**Llwynderw Primary School
Swansea**

Site Assessment 24/04/08

1.0 Introduction

This note presents the findings of a site assessment undertaken on Thursday the 24th April 2008 at Llwynderw Primary School, Swansea.

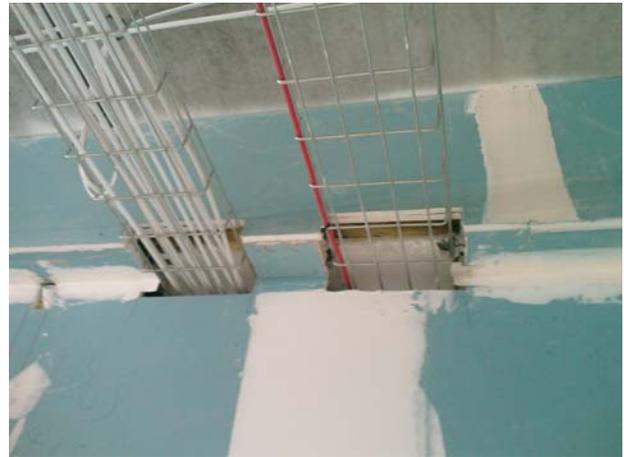
The main service run between classrooms is through separating partitions, as shown below. Services should always run within corridors and break off into classrooms above the doors.

As per Appendix A, all cables passing across a separating partition must be run through square or round trunking, for at least a 0.5m either side of the wall. The trunking is then required to be sealed with sandbags and mineral wool. All gaps should be sealed with non hardening mastic.

The details below are required to be fully sealed with patress panels, with an equal mass to that of the partitions. All holes are to be sealed with mineral wool and non hardening mastic, including the opening to the trunking.

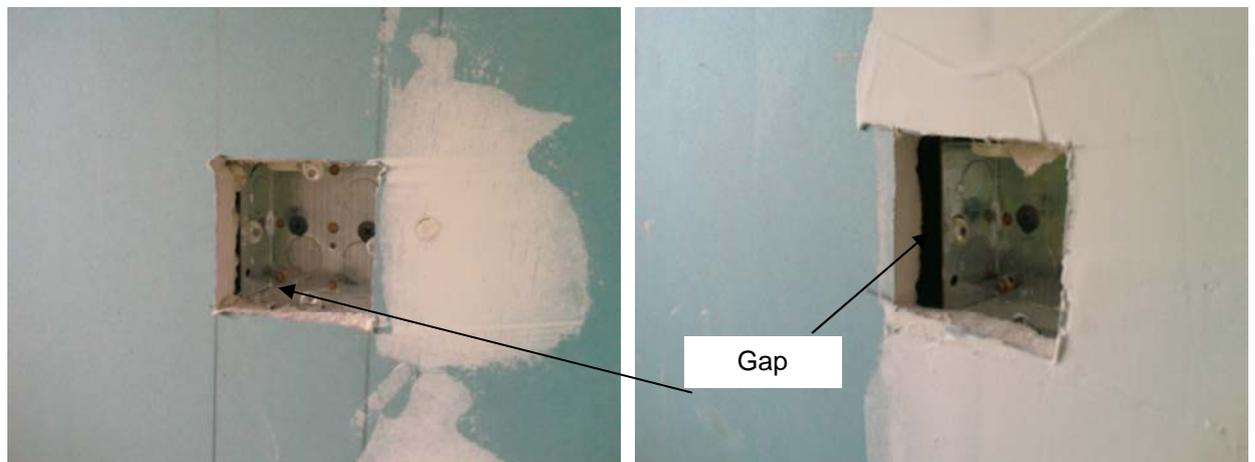
As in the case of classrooms, there are cable trays passing directly between classrooms and adjacent music rooms. Due to the high acoustic performance of the separating wall between these two spaces, cable runs are required to be re-routed.

All services entering and leaving the music rooms must be through the corridor walls only.

3.2 Sealing and Puttied Electrical Sockets

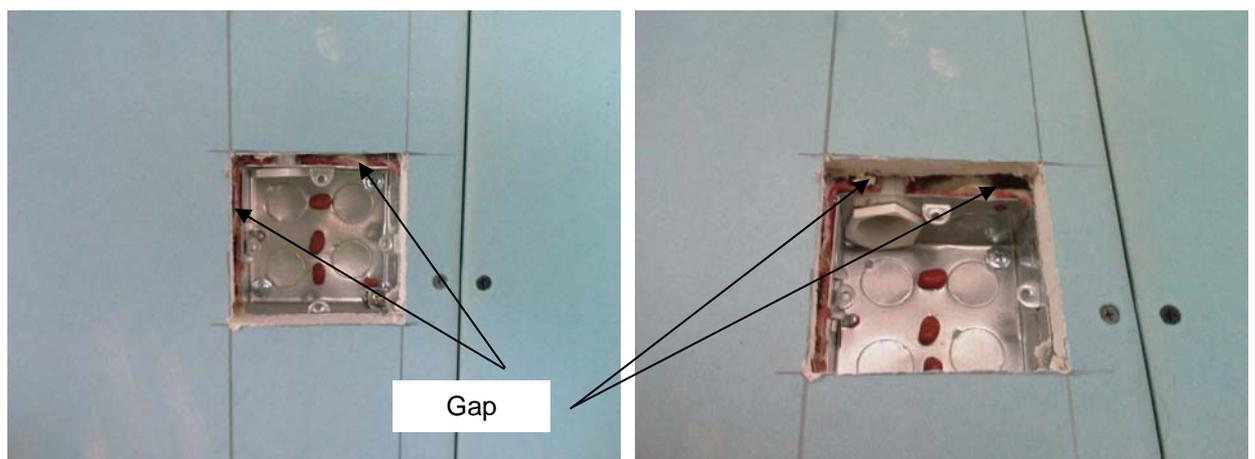
The sockets below have been sealed with putty. On the other hand, the large gaps around the sockets will compromise this detail and negate the effect of the putty.

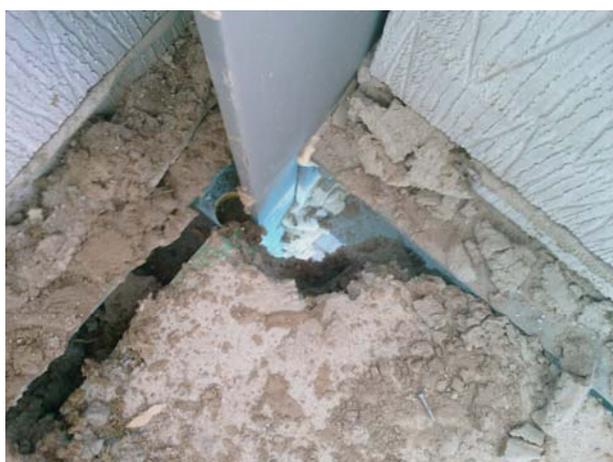
As can be seen from the photo below, walls between classrooms are formed from 1 layer of Soundbloc on one side of the stud, and two layers of board on the other side.

MACH Acoustics do not have data for this form of construction. On the other hand, modelled data for the construction above i.e. one layer of board on one side only and two on the other, shows a 4 dB reduction in the performance of the partition.

Note that this reduction will be reduced if 15mm of Soundbloc is used or if larger studs have been used.

7.0 Moveable walls

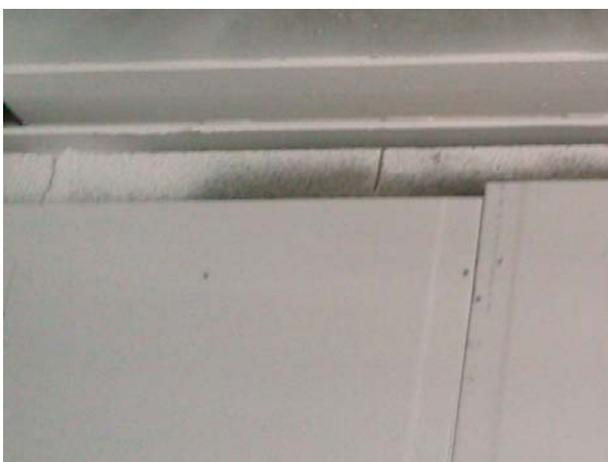
There appears to be a sprinkler pipe passing through the proposed location for the moveable wall within the Reception Classrooms.

It is extremely difficult to achieve acceptable levels of acoustic separation across a moveable wall. It is therefore advised that this pipe be redirected.
